JUNEAU, ALASKA GLACIER HIGHWAY & TRAILHEAD

STAGE II - AMALGA HARBOR ROAD TO KAYAK LAUNCH
STA. 347+50 TO STA. 605+30
STP-093-3(27) ~ 68832

Project As-Built Drawings have been reviewed by the Project Engineer and represent to the best of my knowledge, the project as constructed.
PE *[Signature]* Date 4/11/2011

SHEET NUMBER	TOTAL SHEETS
M1	100

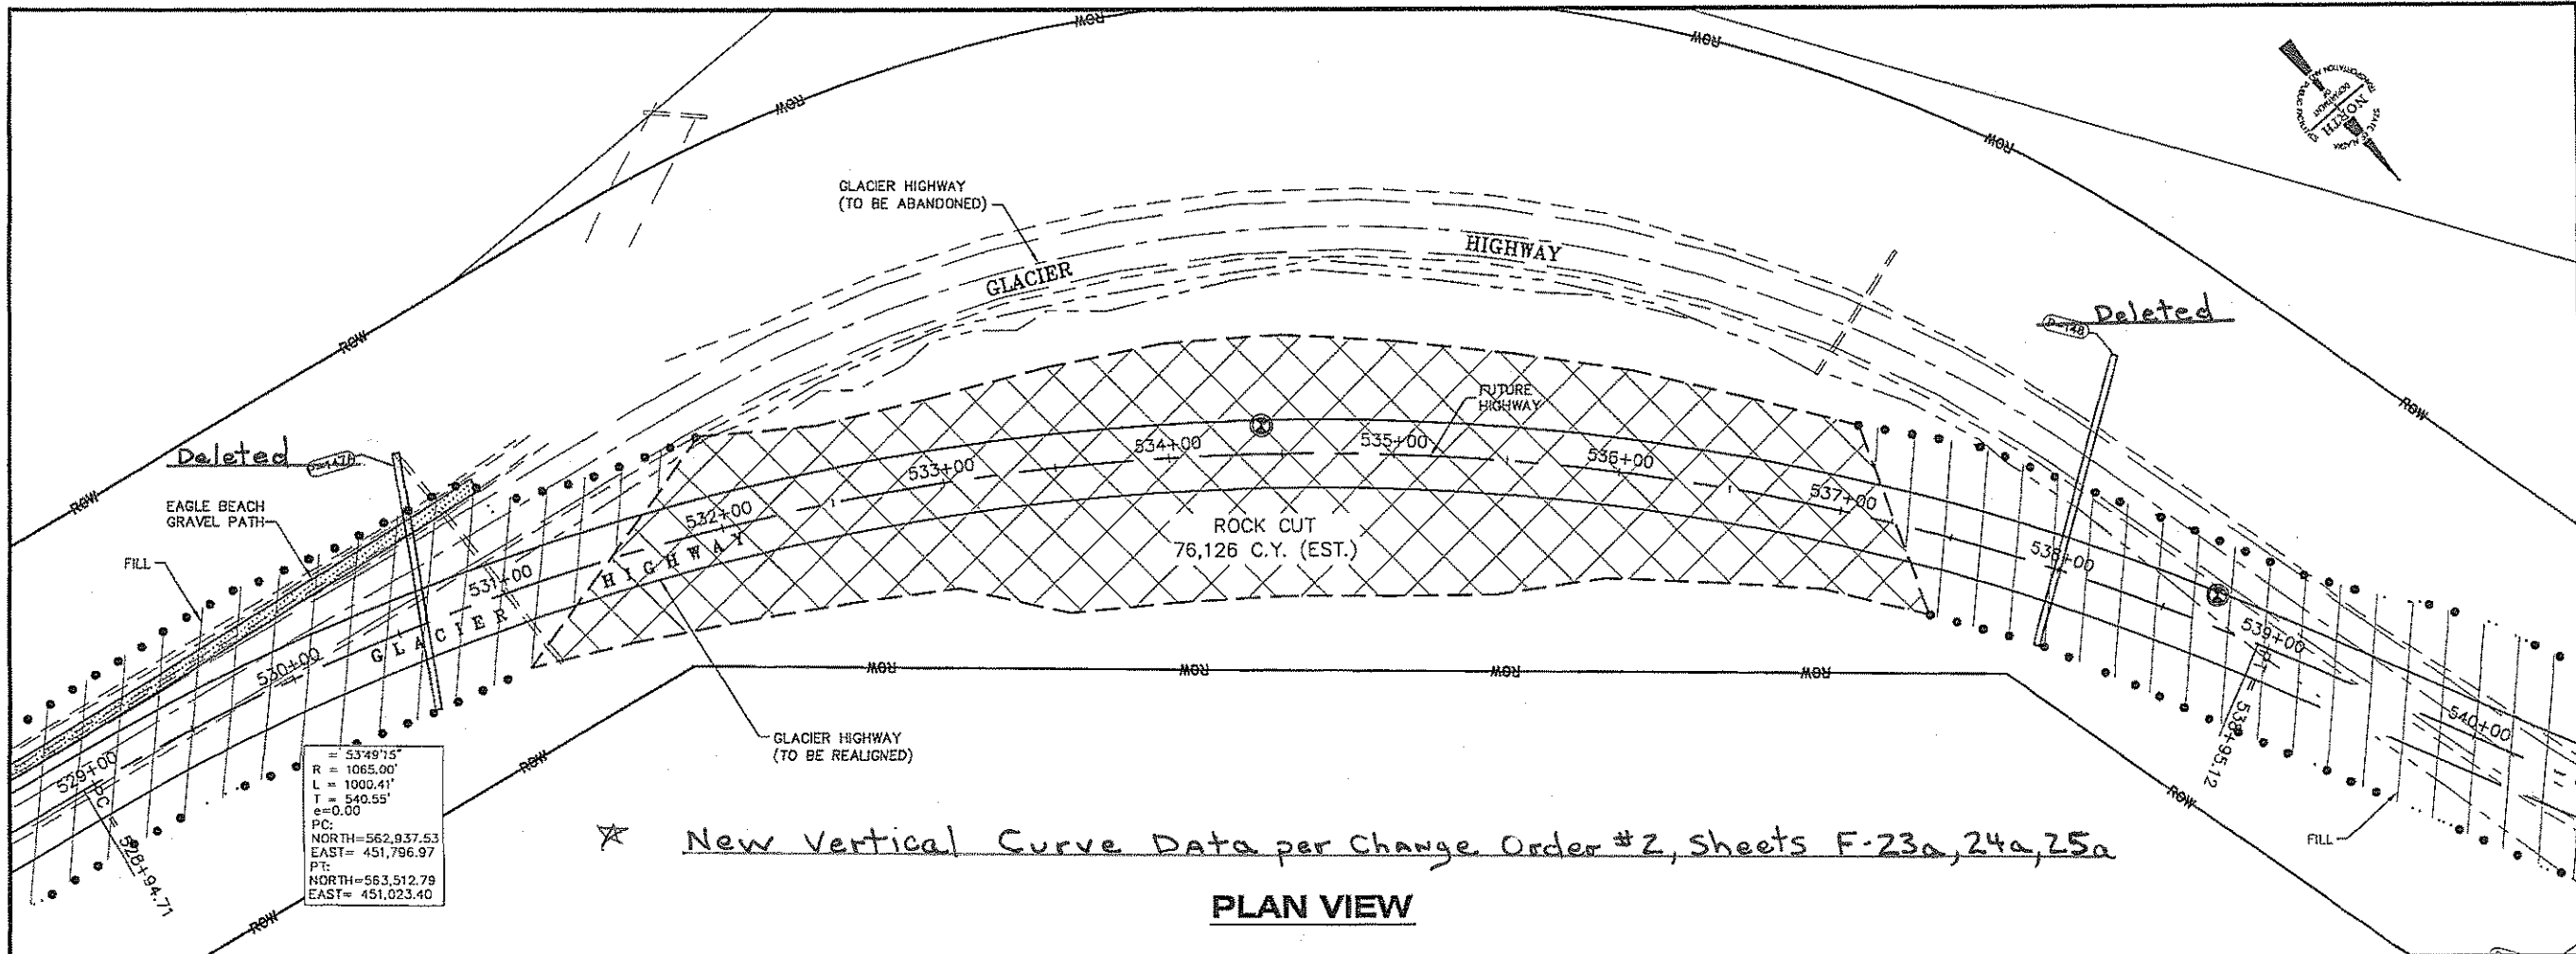
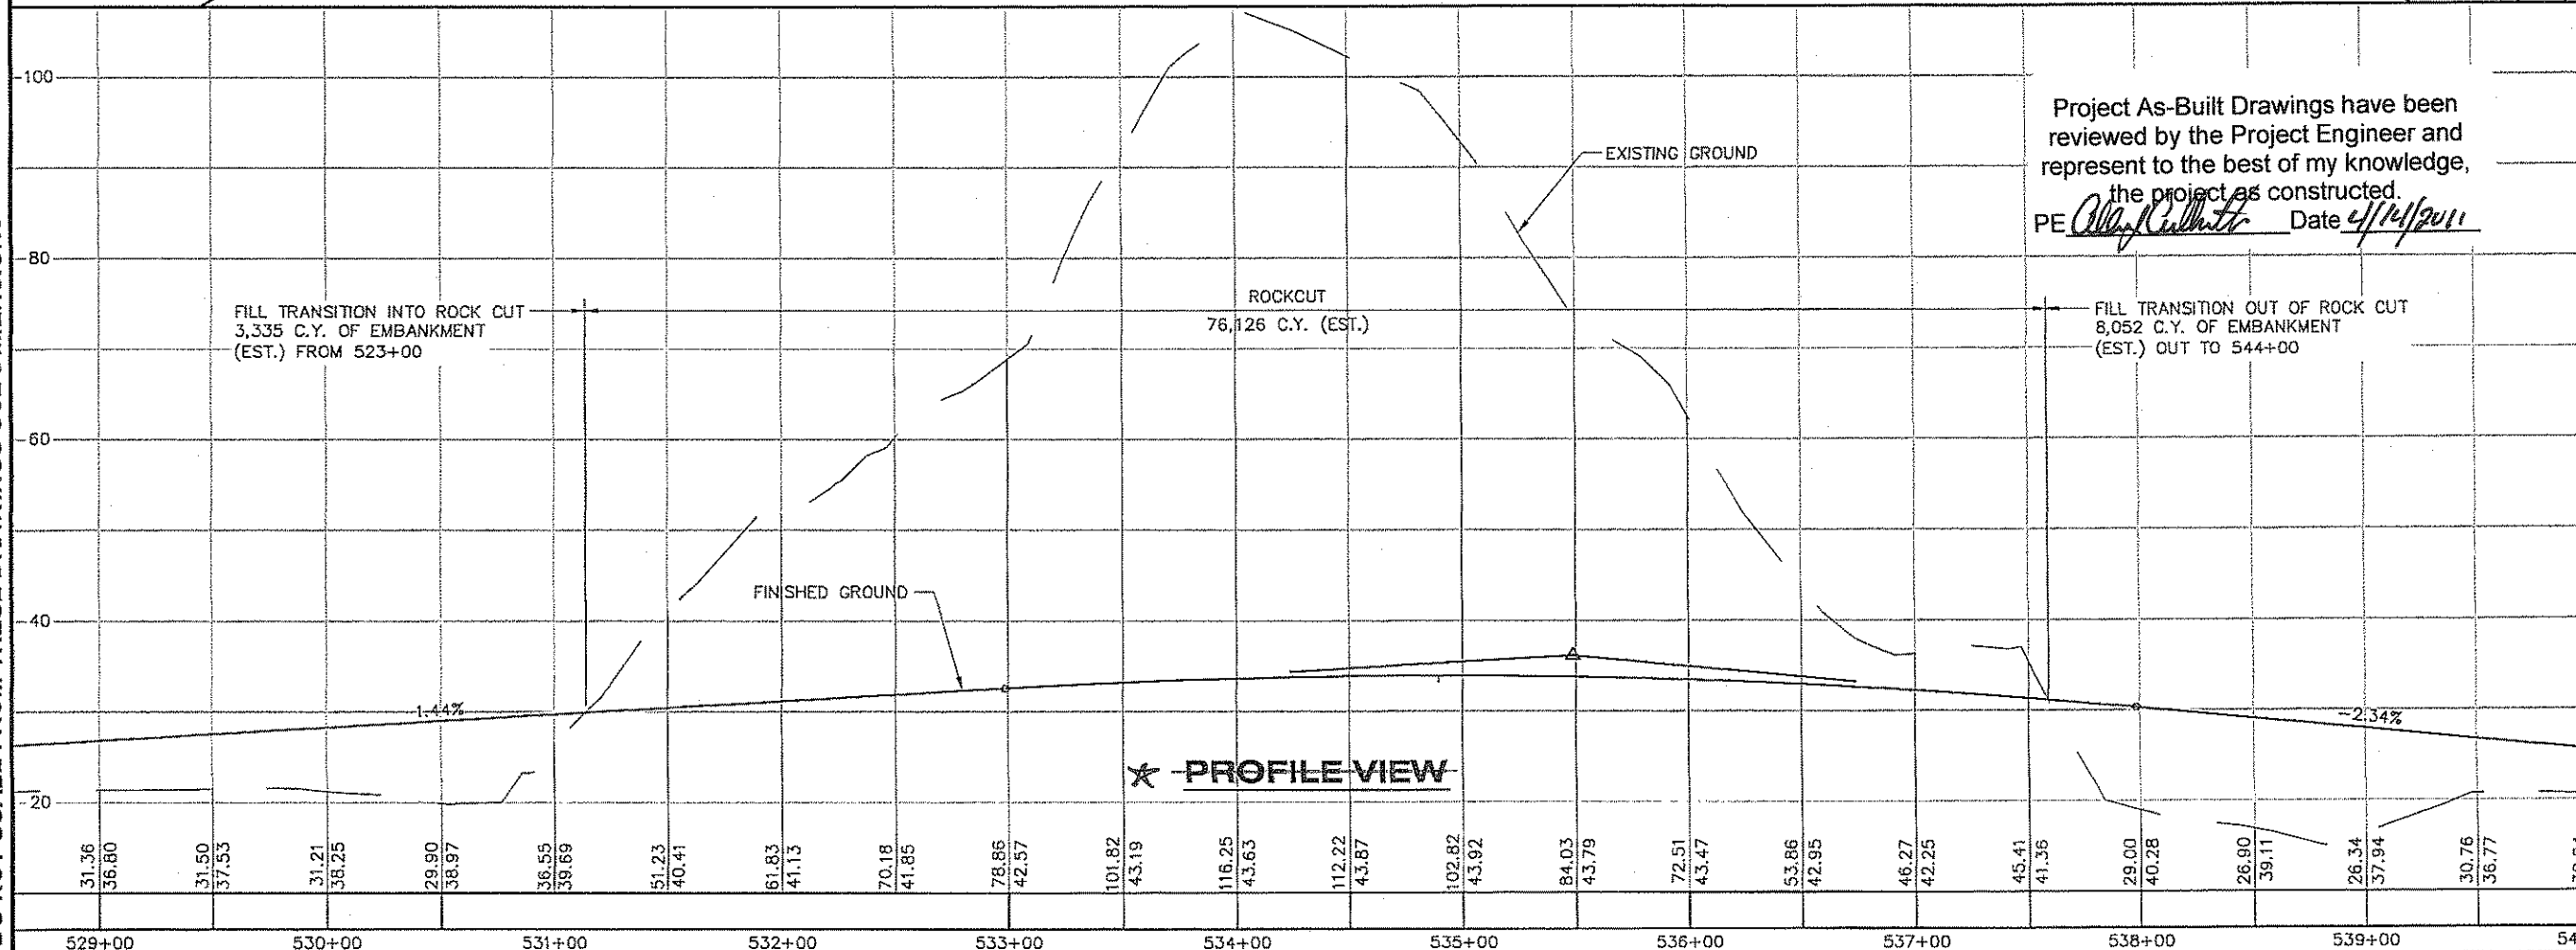
★ New Vertical Curve Data per Change Order #2, Sheets F-23a, 24a, 25a
